Proposed change to Figure 147-5 – PCS Transmit state diagram (part b)

Proposed Changes to Figure 147-5

Figure 147-5—PCS Transmit state diagram (part b)

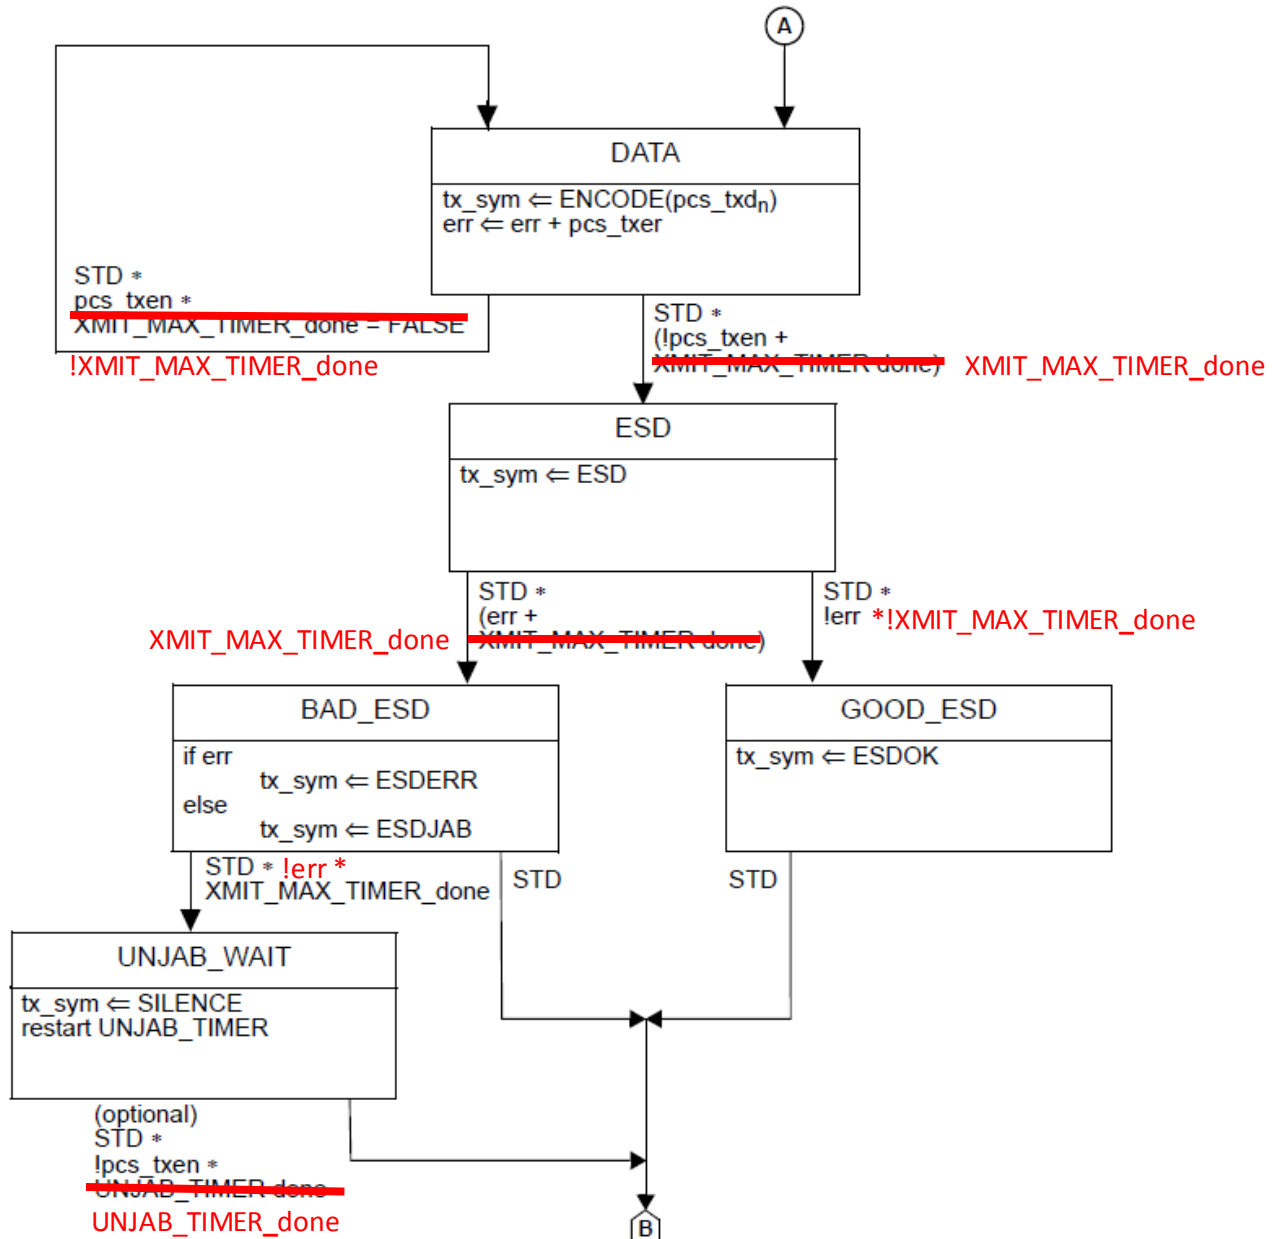
- Figure 147-5, line 36, Page 173
- Comment #327
- Use XMIT_MAX_TIMER_done instead of XMIT_MAX_TIMER_donē
- Use UNJAB_TIMER_done instead of UNJAB_TIMER_donē
- Use !XMIT_MAX_TIMER_done instead of XMIT_MAX_TIMER_donē = FALSE
- Change ESD to GOOD_ESD condition from STD*!err to STD*!err*!XMIT_MAX_TIMER_done
- Change BAD_ESD to UNJAB_WAIT condition from STD* XMIT_MAX_TIMER_done to STD*!err*XMIT_MAX_TIMER_done
